Urgent Field Safety Notice

Subject: Liko® Multirall™ 200 Q-link strap lock replacement

FSCA-identifier: MOD1322

Type of action: Device Modification

Correct vs incorrect attachment of Q-link strap lock of Multirall 200 to S65 rail carriage hook

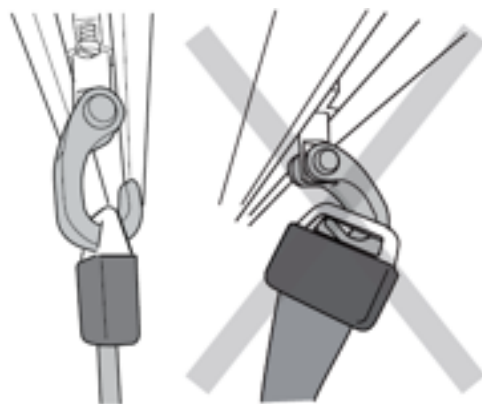
Hillrom continues to receive complaints of incidents where the Multirall Q-link strap lock has not been correctly attached to the S65 rail carriage hook by user (illustrations below). This may lead to the Multirall lift becoming detached from the rail system, potentially resulting in the fall of both the lift motor and the patient. An advisory notice, with reinforcement of the instructions for use was shared with all customers of the Multirall 200 in 2017 (MOD1267), and since then additional complaints of serious incidents due to this use error have been received by Hillrom.

Hillrom will be replacing the Q-link on Multiralls to Q-link II to improve ease of use and mitigate potential risk to patient or caregiver.

The Q-link 2 strap lock design

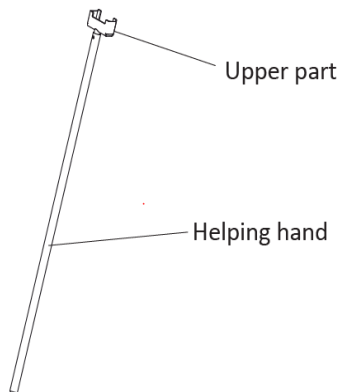
The Q-link II strap lock (illustration below) was introduced on the Multirall overhead lift to resolve ease of use issues with the application of the Q-link strap lock to the S65 carriage

hook, particularly while applying the Q-link strap lock from the ground level with the Extension arm accessory (illustration below). The Q-link II has a larger opening which allows for better visibility while attaching the hook and the rolling feature of the Q-link II strap lock makes it easier to apply on the S65 rail carriage hook.

Extension Belt, adjustable. (3136226, 3136227, 3136228 and 3136229)

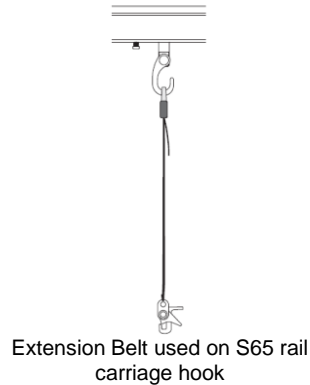
Category B Multirail installations are combined with an **extension belt** (illustrations below)

Once you have identified units affected by this field corrective action and you have returned the response form, you will be contacted by Hillrom or an official Hillrom distributor, to schedule the replacement of the Q-link 1, R2R accessories and extension belts if present in the installations.
